Safety Notice Quick-Out Carabiner on April 01, 2019

The picture on the right shows a Quick-Out carabiner with a faulty mounted release button:

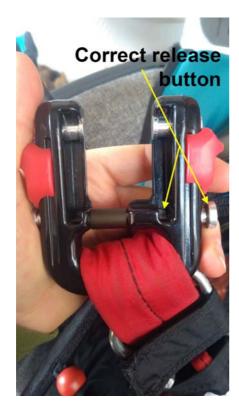
When setting up the production of the Quick-Out release buttons in January 2015, about 20 release buttons of one side were produced incorrectly. Some of these release buttons were accidentally mounted and at least one such faulty Quick-Out carabiner was put into circulation. The error eliminates one of the 4 security levels: To open the carabiner, it is sufficient to press only the correct release button instead of pressing both release buttons simultaneously.

At the final inspection, every single Quick-Out carabiner undergoes a load test of 2,000 DaN. However, the error was not noticeable, since the stress test is also passed with only one release button intact.

If the Quick-Out is operated in accordance with the current version of our operating instructions, which are available for download on our homepage, the error will be noticed immediately. There it is described that the insert of the Quick-Out must click into place by strongly pressing it down (without pressing the release buttons simultaneously). A faulty release button prevents this.

We urge all Quick-Out users to check the carabiners before the next use.

We have introduced additional testing procedures for the final inspection of the Quick-Out carabiners to reliably prevent such errors in the future.
